**LEXINGTON-FAYETTE URBAN COUNTY GOVERNMENT
CONTRACT CHANGE ORDER**

Date: **January 12, 2017**
Project: General Services Building Roof Replacement
Location: 1555 Old Frankfort Pike

CHANGE ORDER: 1

PROPOSAL REQUEST NUMBER: 002

ROOF PLAN & ELEVATION
LFUGG GENERAL SERVICES BUILDING ROOF REPLACEMENT
 1556 OLD FRANKFORT PIKE
 LEXINGTON, KY 40504

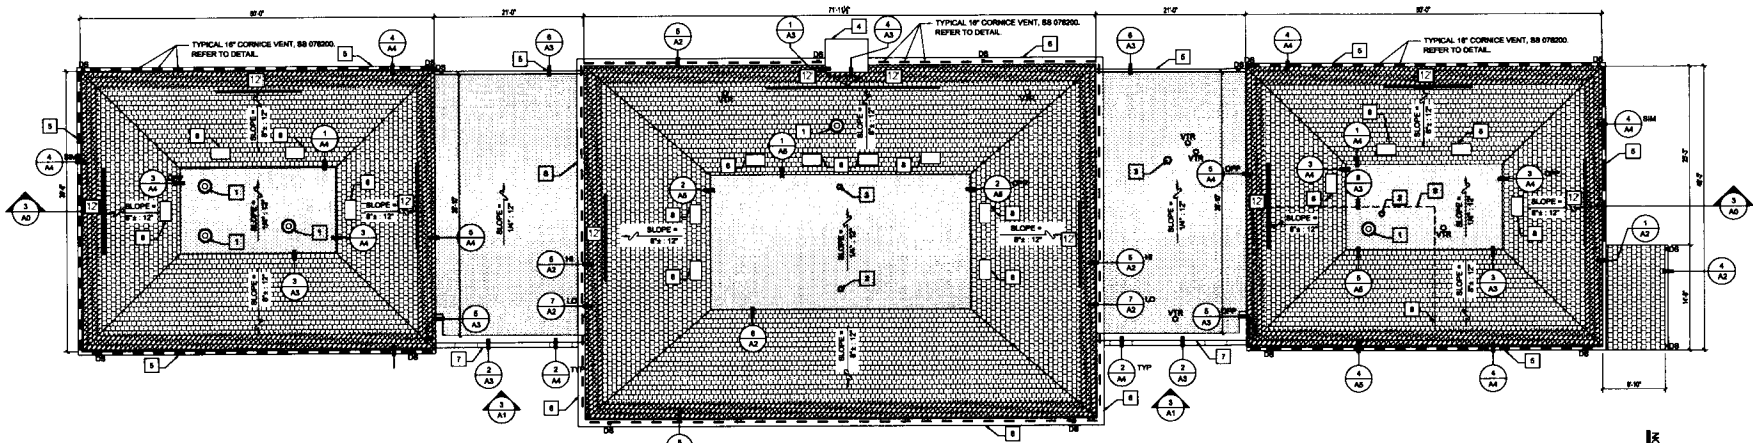
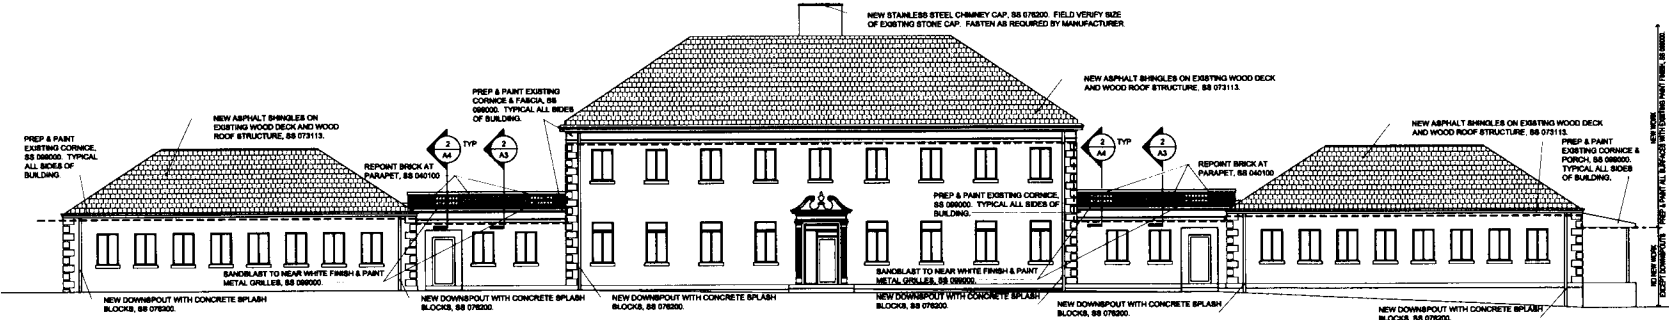
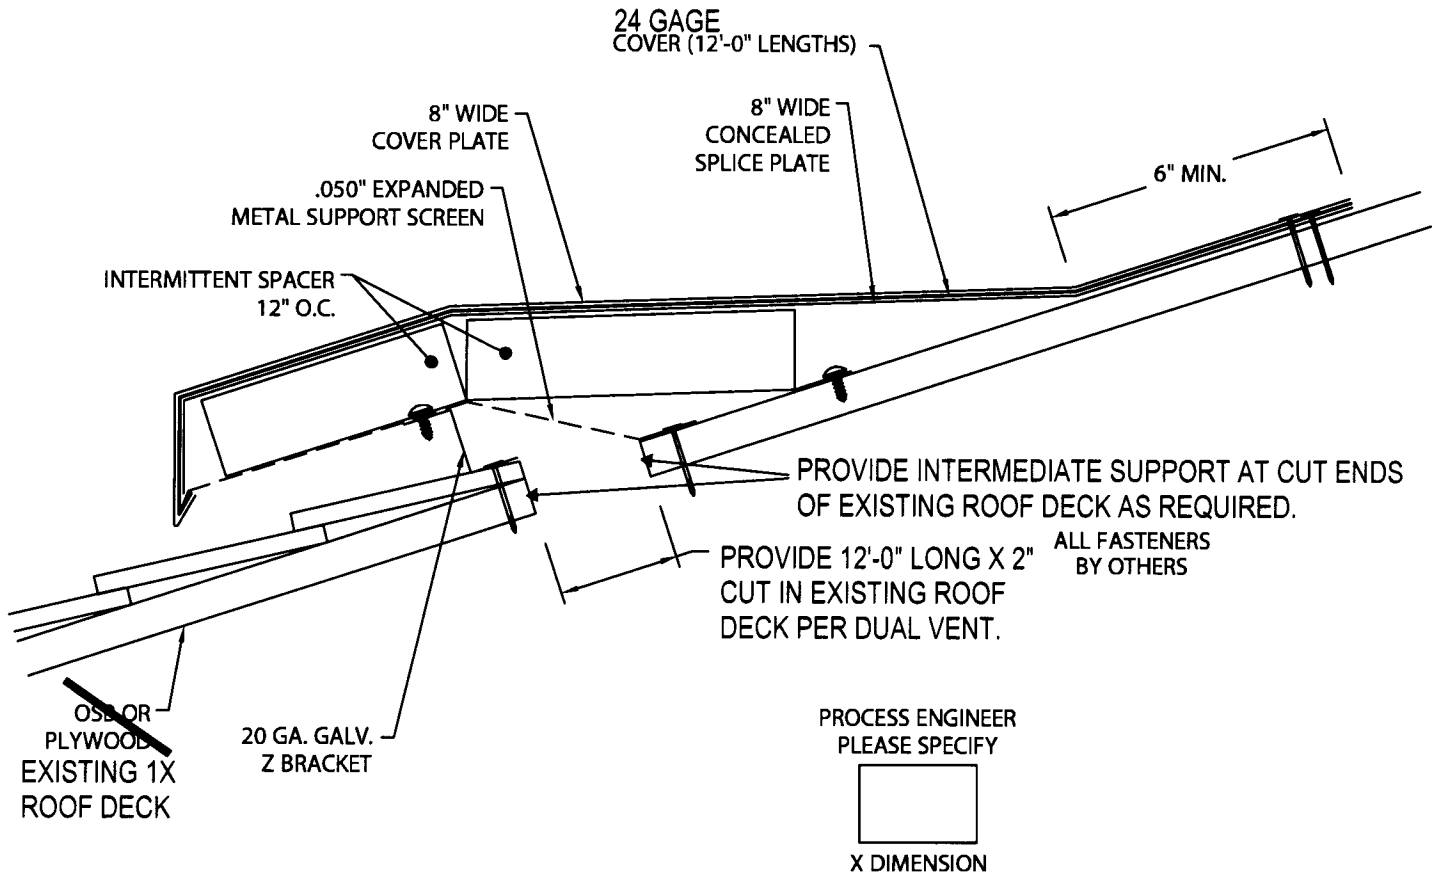
Provide a breakdown of material cost and labor to install ten 12'-0" lengths (120'-0" feet total) of the 24 gage Metal Era Dual Vents and eighteen end caps. The vents shall be located in conformance with the attached plan and installation details. The 2" cut in the roof deck shall occur 3'-6" from the roof eave. Provide intermediate wood support at the cut ends of the roof deck as required.

Provide labor credit for eliminating the cuts to the soffit boards at Areas A, B & C.

Provide labor credit for eliminating the modification of the decorative 1x10 trim board in Area C.

PROPOSAL REQUEST #2
 SUPPLEMENTAL DRAWING #1
 DECEMBER 28, 2016

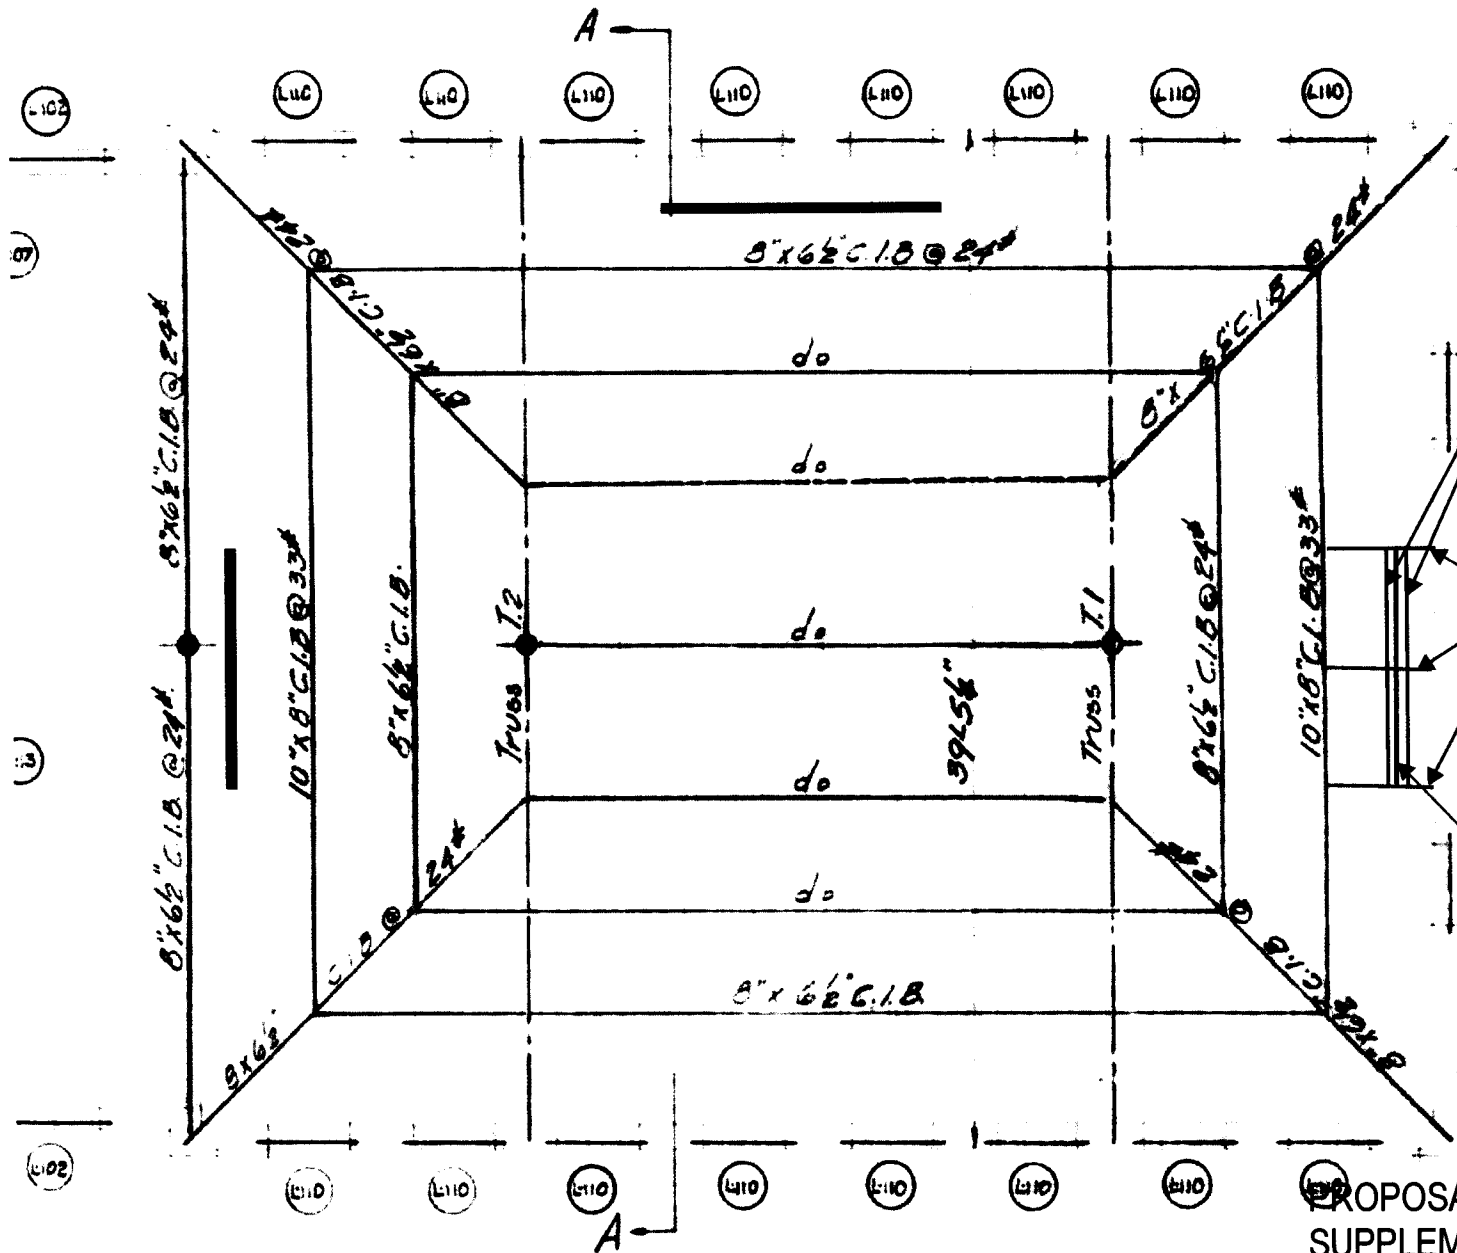
(2) 6 IN., 18 GAGE METAL STUD RUNNING BOTH SIDES FULL LENGTH OF 2" X 12' CUT IN ROOF DECK.

(3) DOUBLE 6 IN. 18 GAGE METAL STUDS RUNNING FROM EXISTING STEEL W SECTION TO MASONRY WALL.

2" X 12' CUT IN ROOF DECK
